Policy Newsletter

February 2026

Policy updates – major policy updates

CP608 – System Control Manual

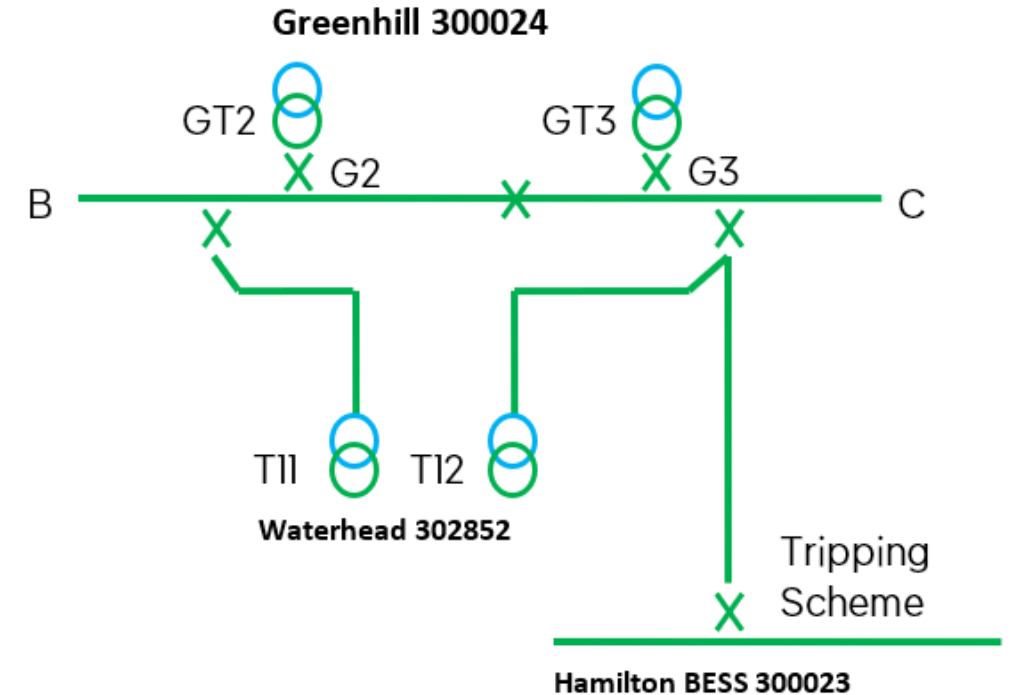
New BESS site commissioned – Operational Procedure

- New Operational Procedure (**OP97**) issued for Hamilton BESS.
- A new connection at Greenhill Grid.

EPD282 – HV Network Design

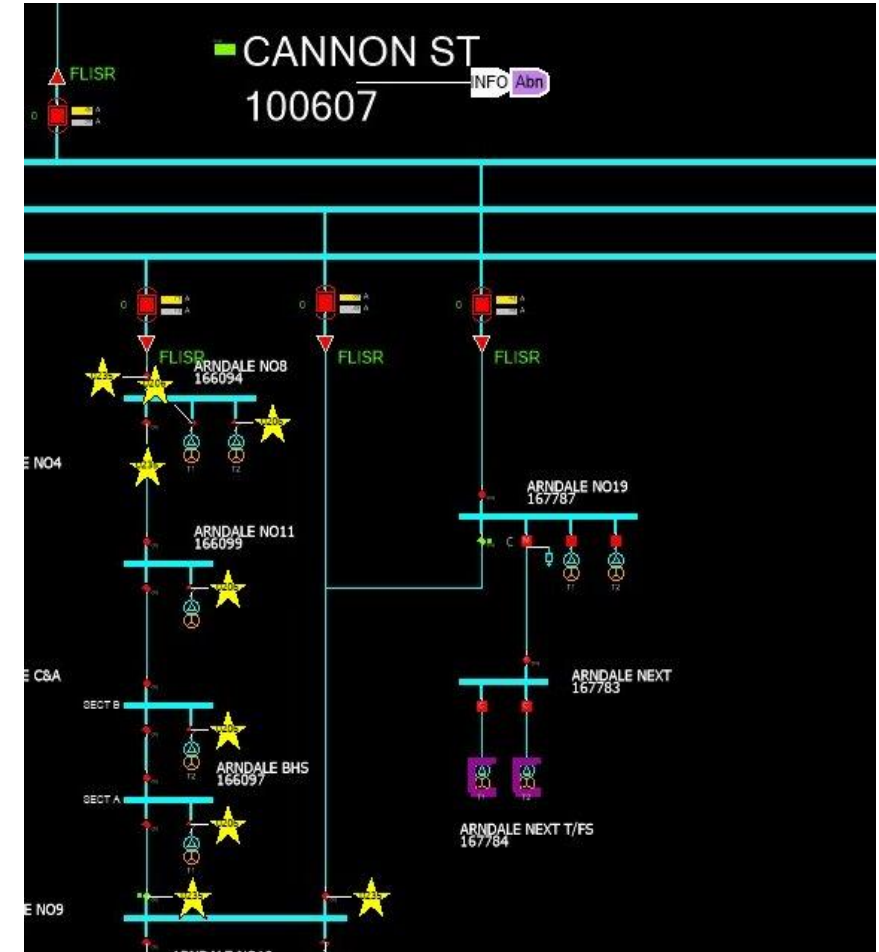
Changes to first-leg tees and remote-control requirements.

- Updated to the new template.
- Interconnected teed circuits are now permitted on the first cable section leaving a primary substation. This allows the full capacity of 630A and 800A circuit breakers to be utilised, where double banking is not possible.
- Remote control requirements - threshold for customer numbers reduced from 200 to 100 to improve CI and CML performance.

Minor amendments in Undergrounding for visual amenity: use of green painted plant and equipment; area of outstanding national beauty renamed; and consideration of CP606 A11 Ch 11 when creating long sections of cable controlled by line switches.
